ARKANSAS POWER & LIGHT COMPANY

Subject: Arkansas Power & Light Company
Arkansas Nuclear One-Unit 1
Docket No. 50-313
License No. DPR-51
Re-Evaluation of ECCS Performance

Attached find responses to those items contained in your letter of November 27, 1975 to Mr. J. D. Phillips concerning the above subject.

FIGURE 1 Reactor Coolant System Flow for 3-pumps operating (percent of total system flow).

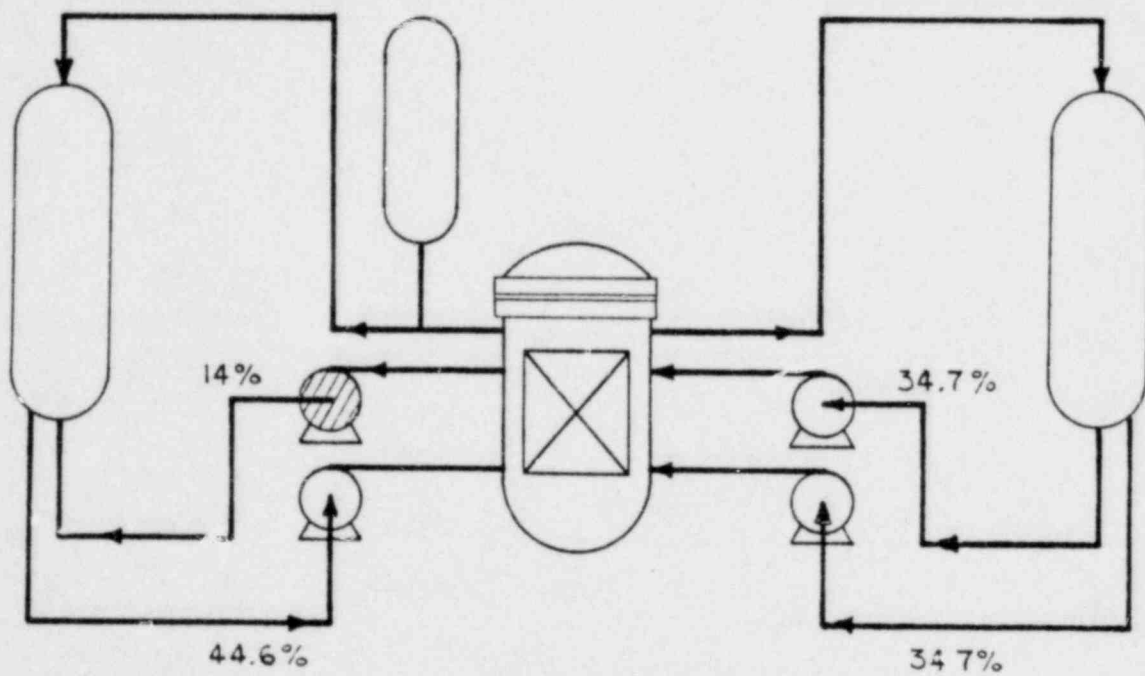
NRC Question 6a

With regard to partial loop analysis:

Discuss the consequences of a break in an active cold leg of the fully active loop.

During steady state, 3-pump operation, the pump in the active cold leg-inactive loop supplies 44.6% of system flow compared to the pump in the active cold leg-active loop which supplies 34% of system flow. Figure 1 shows the Reactor Coolant System flow for 3-pump operation. Therefore, placing the break at the discharge of the pump in the active cold leg-inactive loop instead of the active cold leg of the fully active loop, would yield the most degraded positive flow through the core during the first half of the blowdown. This is due to the loss of the largest source of positive flow and this would result in higher cladding temperature. Thus, analyzing this break location will ensure that the most conservative assumptions affecting core flow have been considered.
